CONVERTIBLE TOP WILL NOT COMPLETELY STOW

This Service Information bulletin replaces SI B54 03 17 dated February 2019.

F57 (MINI Convertible)

GRUSB5417-04

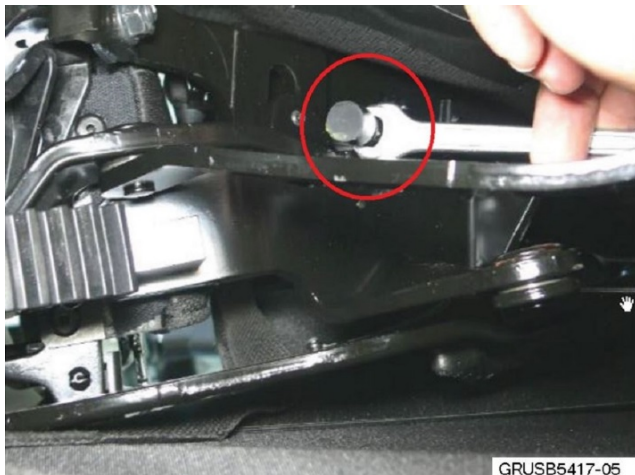
2. Expose the left convertible top spacer adjustment bolt (circled) by opening the loading aid.
3. Loosen the lock nut.
4. Turn the adjustment bolt in 1 - 2 turns.

5. Retighten lock nut.
6. Detach the loading aid from left and right soft-top bow and lock.

Is the convertible top now compressed enough to engage lock on the left side?

YES- The repair is complete.

NO – Repeat the procedure, and turn the adjustment spacer bolt in more.
